DEVELOPMENT CONTROL FORUM MINUTES 14 JANUARY 2021

DEVELOPMENT CONTROL FORUM

21/2/DCF Application and Petition Details(16/1134/OUT / WestCambridge Site Madingley Road Cambridge Cambridgeshire)

Scheme: Amendments to the current Outline Planning Application for the WestCambridge Site

Parameter Plan 5: Maximum Building Heights

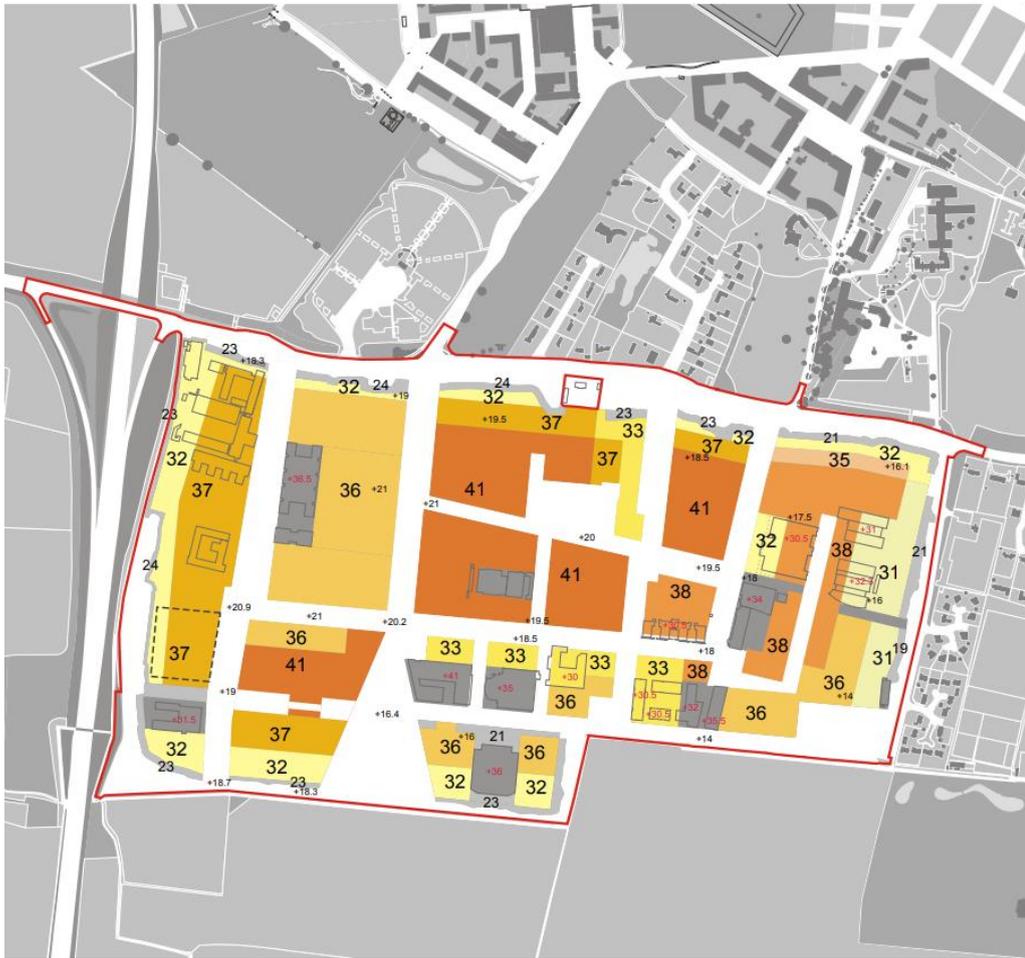
- iii. The height of the flues above the building was considered excessive.
- iv. The proposed buildings due to location and height would overlook the nearest houses and gardens of Perry Court and the Lawns and result in a loss of privacy.

Building heights include roof plant rooms but exclude exhaust flues.
Maximum height of flues to be no more than 8m above maximum building heights.
